REPORT TO THE HEARING EXAMINER

HEARING DATE:	April 14, 2015
Project Name:	Longacres Business Center
Owner:	Longacres Renton, LLC / 3900 E. Camelback Road, Suite 100 / Phoenix, AZ 85018
Applicant:	Molly Carson, Ryan Companies US, Inc. / 3900 E. Camelback Road, Suite 100 / Phoenix, AZ 85018
Contact:	Dave Williams, Ryan Companies US, Inc. / 3900 E. Camelback Road, Suite 100 / Phoenix, AZ 85018
File Number:	LUA15-000076, ECF, SA-H, MOD
Project Manager:	Clark H. Close, Associate Planner

Project Summary: The applicant is requesting Hearing Examiner Site Plan Review, SEPA Environmental Review, and a Street Modification for two (2) standalone buildings totaling 250,825 square feet (SF). The vacant 11.8 acre site is located at the SW Corner of SW 27th St and Naches Ave SW. Building A is a three-story 146,910 SF general office use building and Building B is a two-story general office, laboratory, and warehouse space building. The two buildings will incorporate tilt-up concrete panels in conjunction with steel framing and light gauge metal construction with heights at roughly 46 feet and 36 feet. Site access will be served from SW 27th St and Naches Ave SW. The project site is located in th

EXHIBIT 6

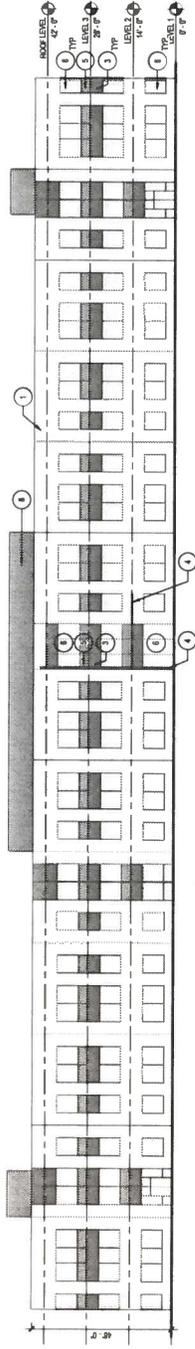
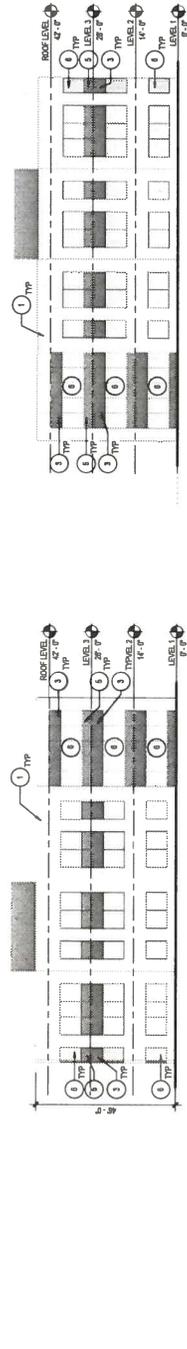
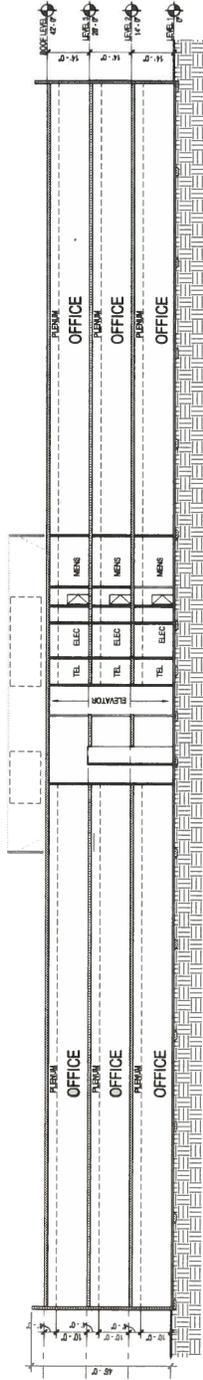
Staff Comment: The 3-story building (Building A) has a building height of 46 feet (Exhibit 6). The structure has a parapet around the building that is 4 feet above the roof level (42 ft). The 2-story building (Building B) has a building height of 36 feet (Exhibit 6). The structure also has a parapet around the building and the roof height is 32 feet above grade. The proposal complies with the height requirements for commercial structure within the CO zone.

Staff Comment: The application has roof mounted mechanical equipment on both structures that will be screened around all sides, approximately 8 feet above the top of the parapet, in order to minimize the impacts on the pedestrian environment and adjacent uses. Compliance with rooftop screening will be verified at the time of building permit construction.

6 TRASH ENCLOSURE DETAIL
1/8" = 1'-0"

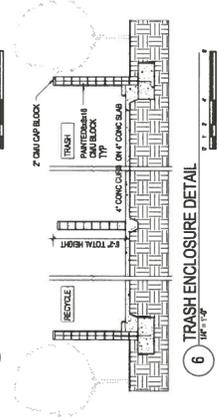
The refuse and recyclable area will be located within CMU block walls. The structure as described in detail in the previous subsection "b. Zoning Compliance and Consistency" Refuse and Recyclables.
